May 3, 2006

MEMO TO: Mr. Keith Wilkins, Director, Neighborhood & Environmental Services Department
THRU: Mr. Doyle Butler, Chief, Environmental Quality Division
Mr. Timothy Day, Environmental Quality Division

SUBJECT: Perdido Key Dune: Final Status Report

Figure 1 – As Built profiles of Eastern Portion of EED, as measured, and the Design Template

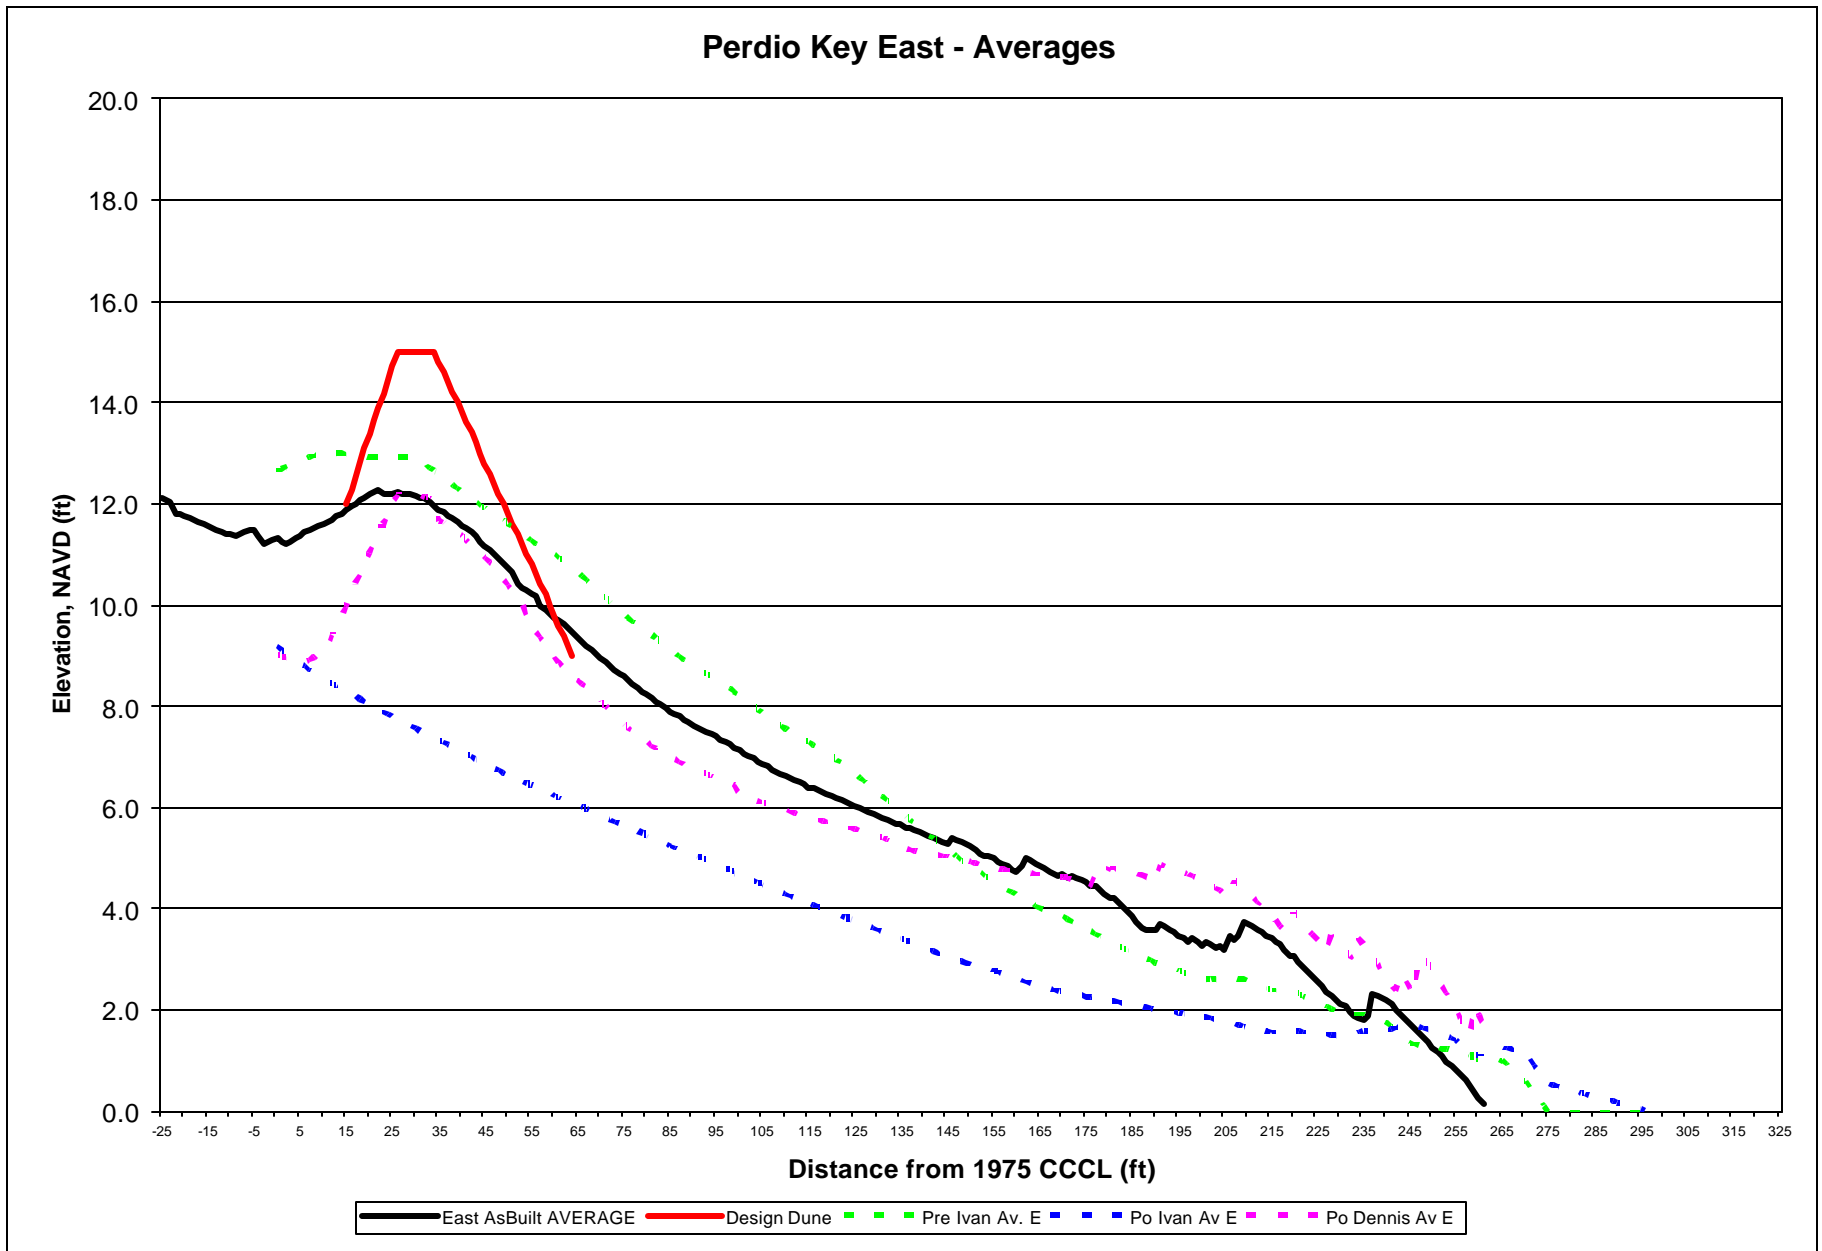
A. Figure 1 shows an overlay plot of all of the cross sections and the design template for the EED for the Eastern Portion of the Project. If the baseline for the survey data is the 1975 CCCL (as requested of HMM) the first impression is that the dune meanders significantly around its design position. Disregarding the easternmost 1000 ft (stations 94+00 to 104+00) where the design crest line was deliberately moved as far north as practical, only 5 out of 22 profiles, representing about 25 % of the Eastern Portion, have the north edge of the crest within ± 4 ft of the design location (26 ft south of the 1975 CCCL).

Figure 2 – Averages of the As Built EED, Pre and Post Ivan, Post Dennis profiles, and the Design Template for the Eastern Portion of the Project

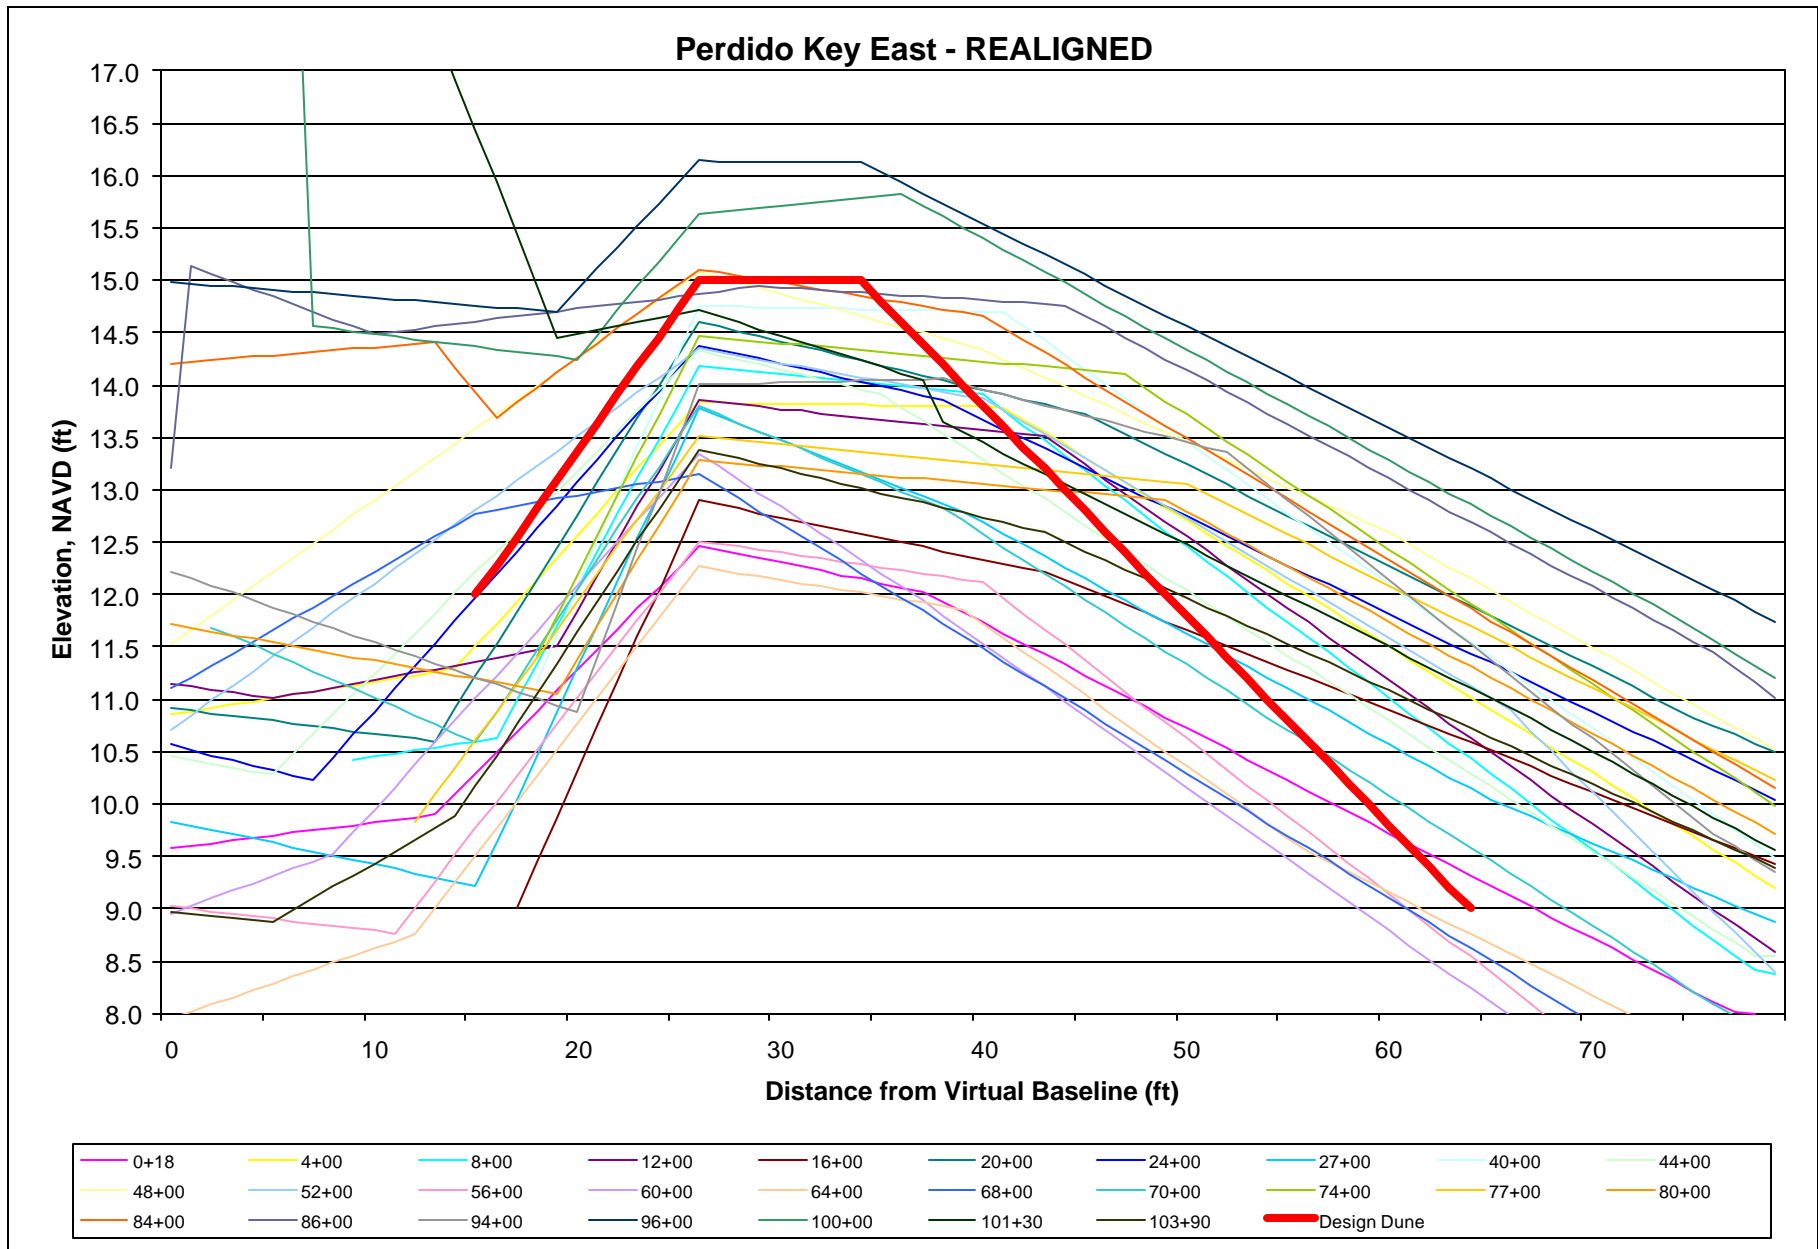
B. Figure 2 shows the average of all of the cross sections for the EED, the average pre and post Hurricane Ivan cross section, the average post Hurricane Dennis cross section, and the design template for the Eastern Portion of the Project. In general, the foreshore has recovered slightly above the pre Ivan condition, while the back shore and dune are roughly 1 ft below the pre Ivan profile. The crest of the average profile of the EED has a peak elevation near +12.2 ft NAVD, is about 8 ft wide, and is displaced 4 ft landward from the design position.

Figure 3 – Realigned profiles of Eastern Portion of EED and the Design Template

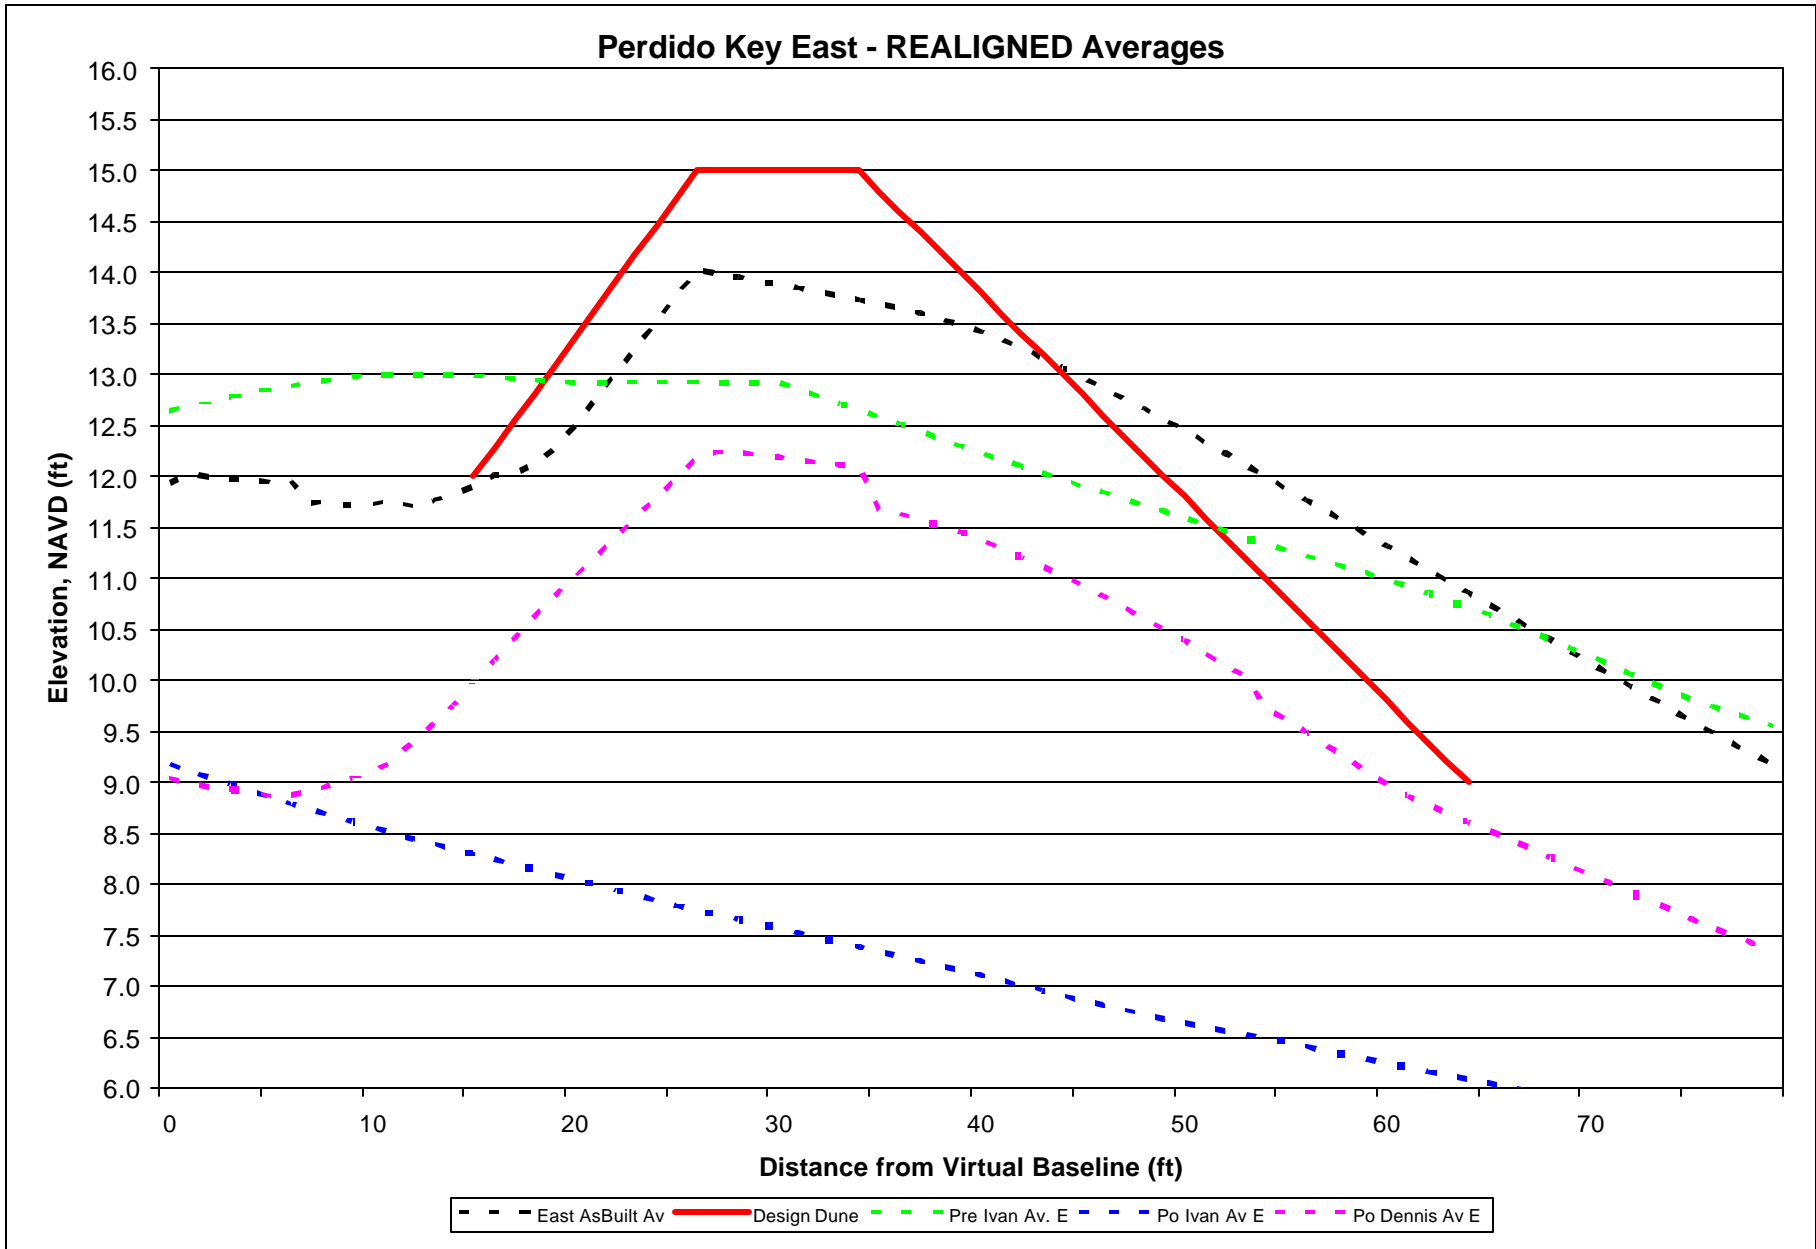
C. Figure 3 shows each profile of the Eastern Portion of the Project manually realigned to place the north edge of the crest at the design position in order to evaluate constructed dune shape, regardless of position, and the EED design template. It is obvious that most of the profiles are significantly lower and much wider than the design.

Figure 4 - Averages of the realigned EED profiles with Pre and Post Ivan, Post Dennis profiles, and the Design Template for the Eastern Portion of the Project

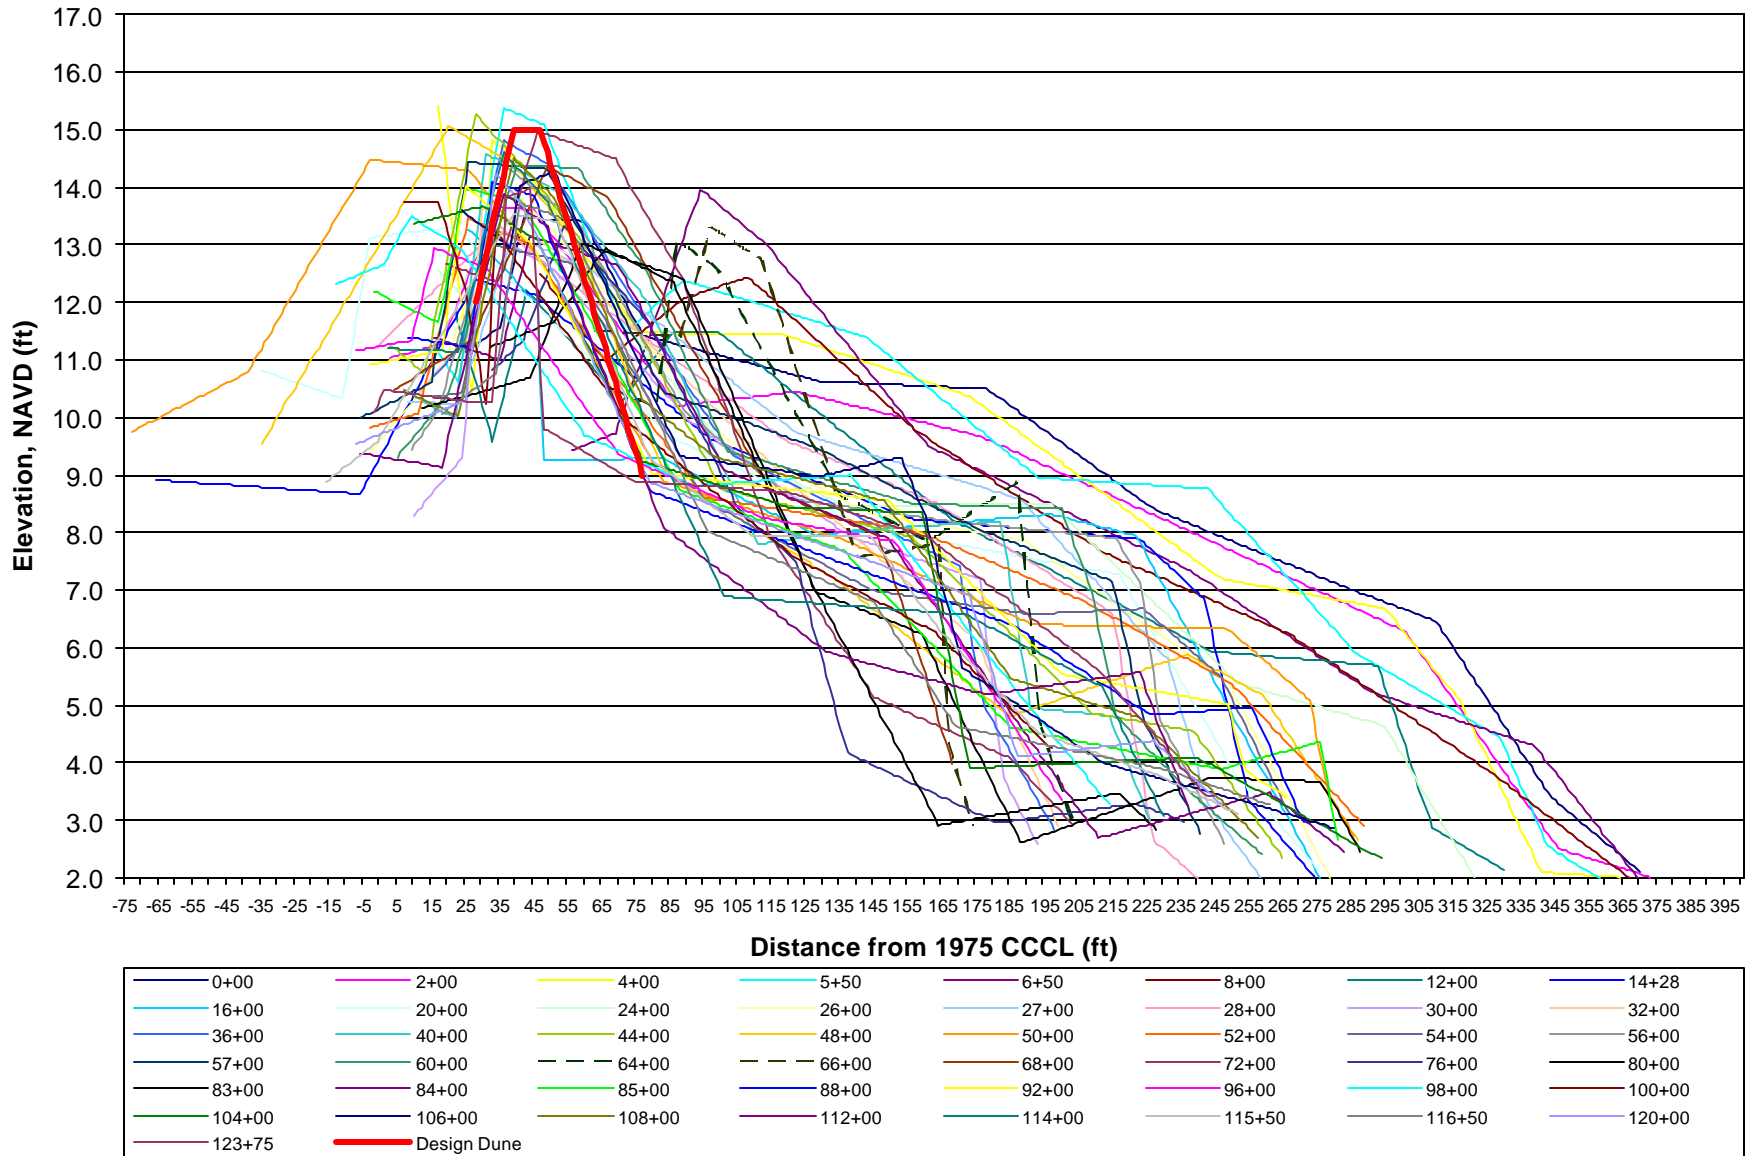
D. Figure 4 shows the average of all of the realigned cross sections for the EED, the average pre and post Hurricane Ivan cross section, the average post Hurricane Dennis cross section, and the design template for the Eastern Portion of the Project. The average crest elevation of the realigned dune is very near + 14 ft NAVD (it slopes from + 14 ft at the north edge to + 13.7 ft at the design south, or seaward edge). The average foreslope is considerably flatter than the design.
